# Technical Memorandum

To	North Kent 1 LP	Page	1
CC	Mark Van der Woerd (AECOM), Jody Law, Joshua Vaidhyan		
Subject	<b>North Kent Wind 1 (Chatham-Kent, ON)</b> <b>Well Water Impact Complaint Investigation – UPDATED v.2</b> [REDACTED] - PIN 007460069, [REDACTED]		
From	Jason Murchison, P.Geo.		
Date	November 15 <sup>th</sup> , 2017	Project No.	60343599

**AECOM SAMPLE**  
(August 2<sup>nd</sup>, 2017)

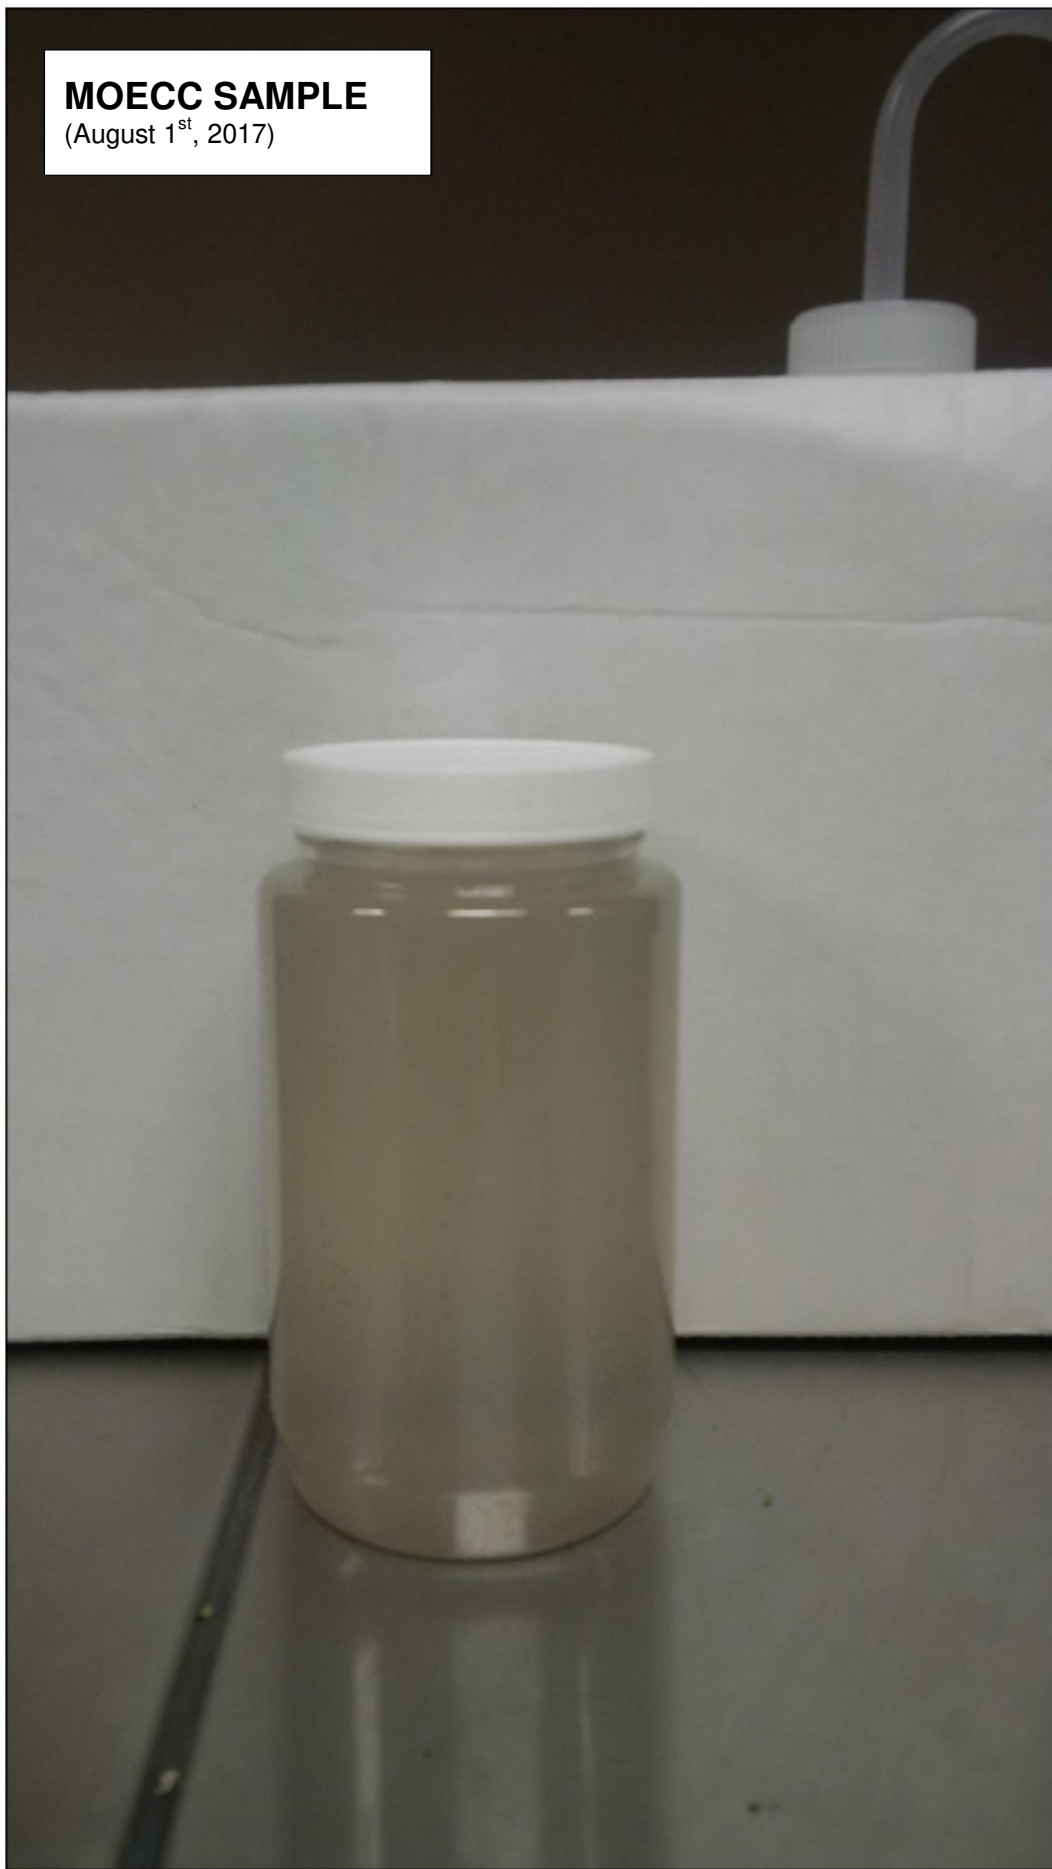
I have also seen a photo provided by [REDACTED] via email to Jody Law the evening of Aug. 3. It purports to be a photo of the sample taken by AECOM during their Aug. 2 visit to the [REDACTED] residence. In that photo, the sampled water appears noticeably cloudy (see attached)

I am trying to reconcile this varying information. Is AECOM saying that the cloudy water collected and photographed during the Aug 2, 2017 visit is visually the same as the 6.2 NTU samples taken Feb. 2, 2017? Are there any photos of the Feb 2 sample? I am hoping that Aecom's report will address / answer these questions.

At the site well, turbidity levels in the samples fluctuate between a baseline (raw - AECOM) value of 6.2 NTU up to 86.8 NTU (raw - MOECC) on 1-August-2017. A raw water sample value of 57.3 NTU was determined on the subsequent day (2-August-2017). In considering this data, it should be noted that a turbidity variation of greater than 50 NTU would be readily visible to the naked eye, and thus present an adverse impact to the aesthetic quality of the groundwater source. Elevated turbidity levels of this magnitude may also lead to flow restrictions within the residence based on the capacity of the installed water treatment system and rate of sediment accumulation.
